TYPICAL PAVEMENT MARKINGS AT ENTRANCE RAMPS

LAST REVISION 11/01/21	DESCRIPTION:		FY 2022-23 STANDARD PLANS	INTERCHANGE MARKINGS	INDEX	SHEET
					711-003	2 of 8

TWO-LANE PARALLEL-TYPE ENTRANCE WITH ADDED LANE  
(Single-Lane Parallel-Type Entrance Without Added Lane Similar, See Note 3)

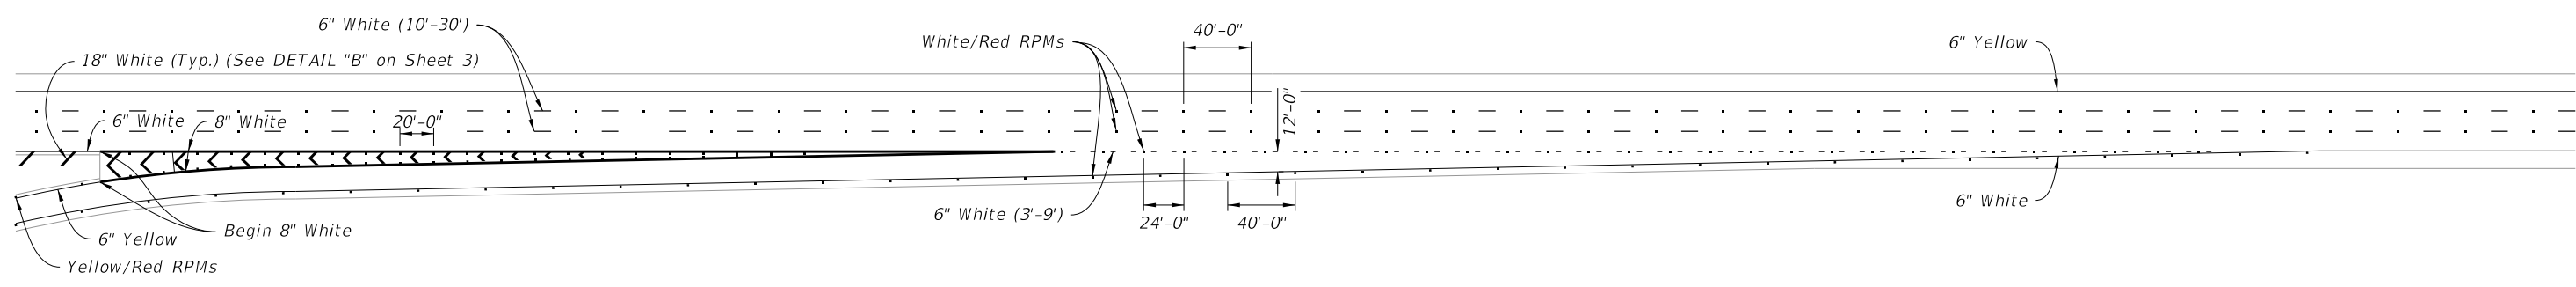
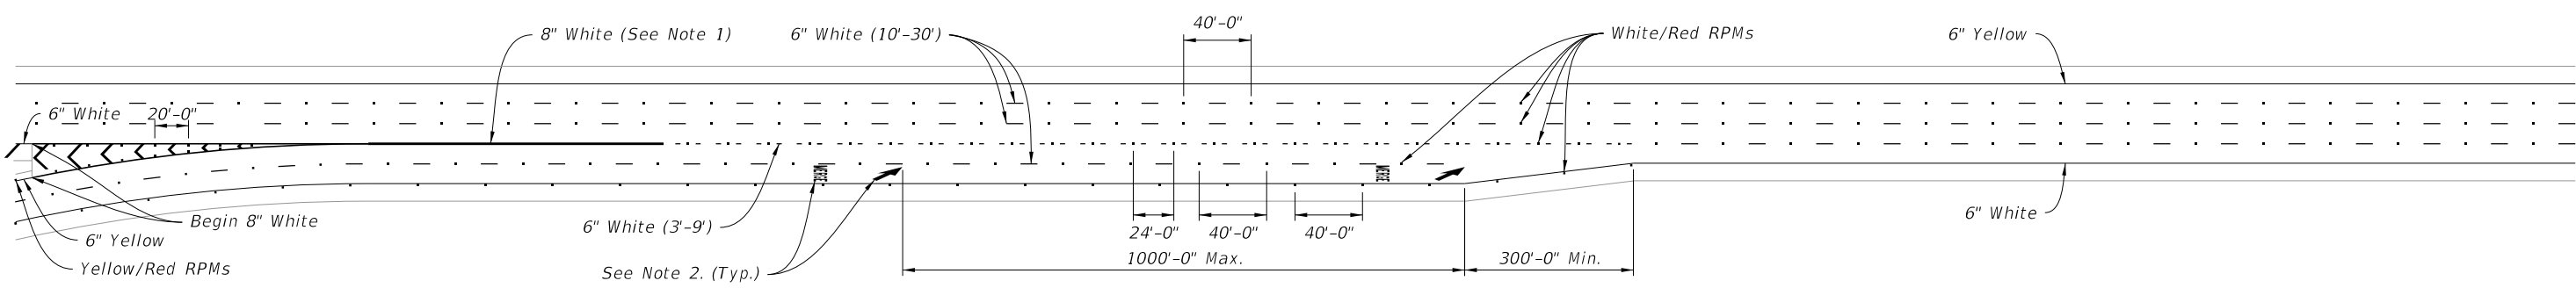
Revised Note to clarify use of dotted interchange line.

1. Extend this 8" white Pavement Marker one-fourth the length of the acceleration lane from the gore markings.
2. See Index 711-001 for pavement message dimensions and details.
3. Discontinue the 6" White (3'-9") Dotted Interchange Line where the merging taper begins for a Single-Lane Parallel-Type Entrance Without Added Lane. Merge Pavement Message and Arrow only used for Two-Lane Entrances.
